**SB-10045302-1806**SI M17 05 12  
Cooling SystemsSeptember 2012  
Technical Service

**Service Action: Retrofit of the Engine Coolant Temperature Sensor**

R60 with automatic transmission (N16 or N18 engine)

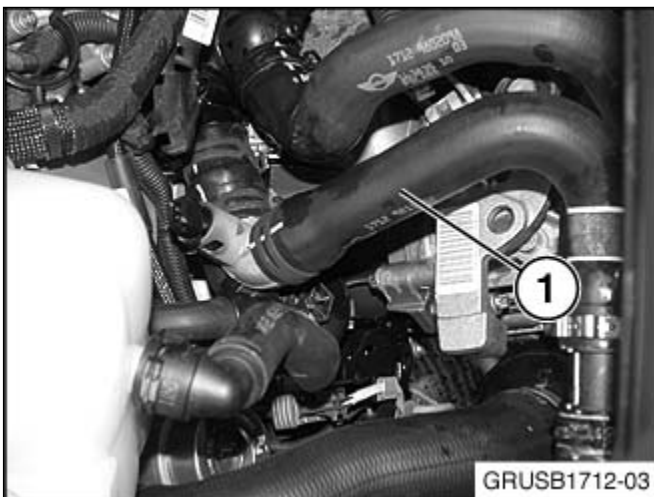
N18 engine only! Install spacer P/N 64 53 7 578 707 (1) on the coolant line as shown.

Note: The spacer needs to stay in this position when installing the new coolant hose P/N 17 12 9 811 351 (next step).

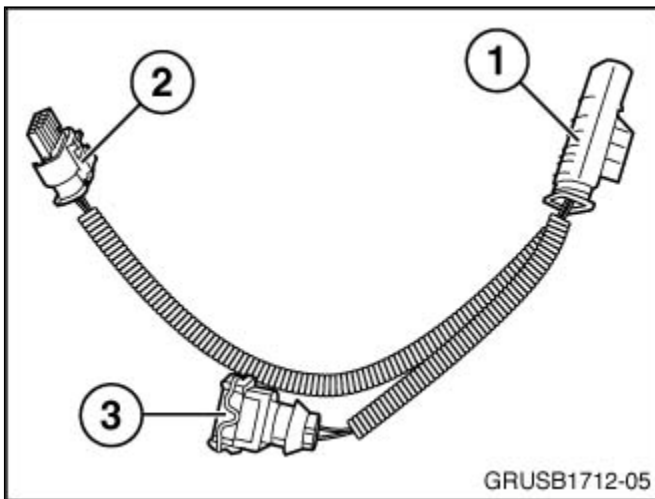
Install the new coolant hose with sensor P/N 17 12 9 811 351 (1).

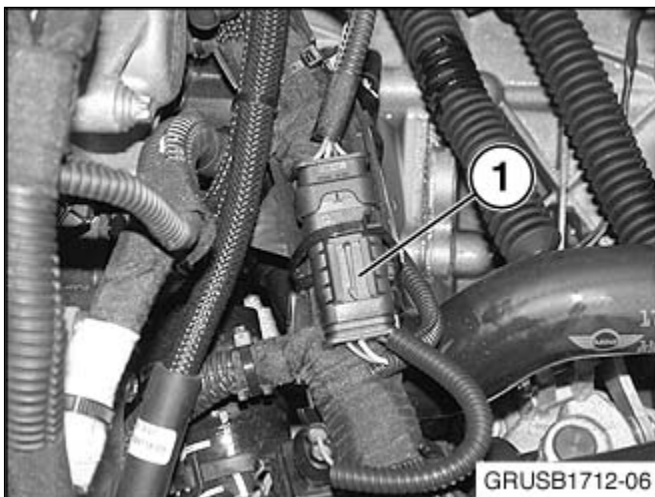
Unplug connector X6279 from the engine thermostat (1).

Plug connector X6279 into the 4-pin male connector (1) of adapter harness P/N 12 51 7 647 200. Insert the 4-pin female connector (2) of the adapter harness into the engine thermostat. Plug the 2-pin female connector (3) from the adapter harness into the engine temperature sensor of hose P/N 17 12 9 811 351.
